**City of Richmond**  
Urban Development Division

## Report to Committee

**To** Planning Committee **Date** July 4, 2005  
**From** Terry Crowe **File** RZ 04-278250  
Acting Director of Development  
**RE** **APPLICATION BY CENTRO DEVELOPMENT LTD FOR REZONING AT 22760, 22780, 22800, 22820 AND 22840 WESTMINSTER HIGHWAY FROM SINGLE-FAMILY HOUSING DISTRICT, SUBDIVISION AREA F (R1/F) TO COMPREHENSIVE DEVELOPMENT DISTRICT (CD/24)**

22760 – 22840 WESTMINSTER HIGHWAY (RZ 04-278250)

SITE PLAN

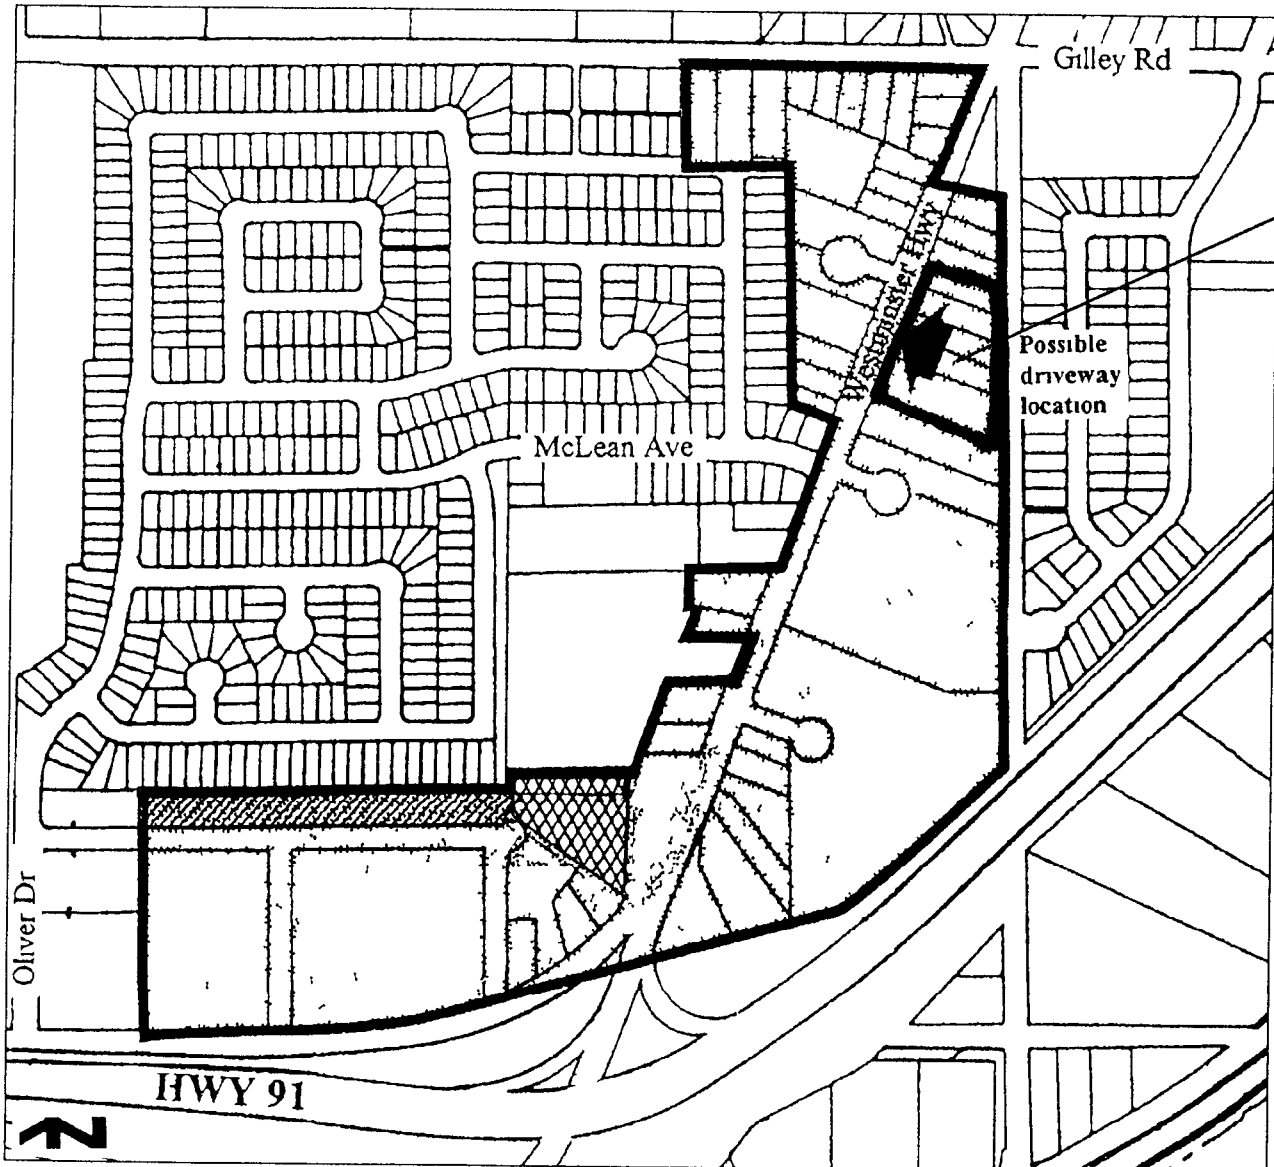
- 1 Units along Westminster Highway will have to have fronting character. The elevations submitted show landscape terracing. There should be some openings and accesses to individual units.
- 2 Floodplain covenant is required.
- 3 ESA Comments  
At the Development Permit stage, Staff will be seeking additional information to address:
  - 1 the need for some form of slope stabilization or other bank applications as part of foreshore enhancement works,
  - 2 the location of fill on the site and its relationship to the ESA,
  - 3 a review of cross sections of the entire Queens Canal right-of-way to determine the impact of enhancement works on the canal, and
  - 4 ensure that enhancement works will not interfere with the future ability to carry out the ongoing maintenance of Queens Canal.

- 1 On-site parking should meet the bylaw requirement for handicapped parking.
- 2 7.5 m wide driveway is to be provided off Westminster Hwy (**applicant has provided**).
- 3 Public Rights Of Passage right-of-way is to be provided to connect properties to the north, including a 7.5 m wide east/west drive aisle off Westminster Hwy, and a 6.0 m wide north/south drive aisle connecting to 22880 Westminster Hwy.
- 4 Applicant is responsible for the design and construction of frontage improvements along Westminster Highway to include (starting at the east property line) 1.5 m sidewalk, 1.5 m

- 5 Applicant to demonstrate how loading can be accommodated onsite, SU-9 and WB-17 are to be used as design vehicles (*applicant has demonstrated on latest plans*)
- 6 At the Building Permit stage, a construction parking and traffic management plan to be provided to the Transportation Department to include location for parking for services, deliveries and workers and loading, application for request for any lane closures (including dates, times, and duration), and proper construction traffic controls as per Traffic Control Manual for Works on Roadways (by Ministry of Transportation) and MMCD Traffic Regulation Section 01570
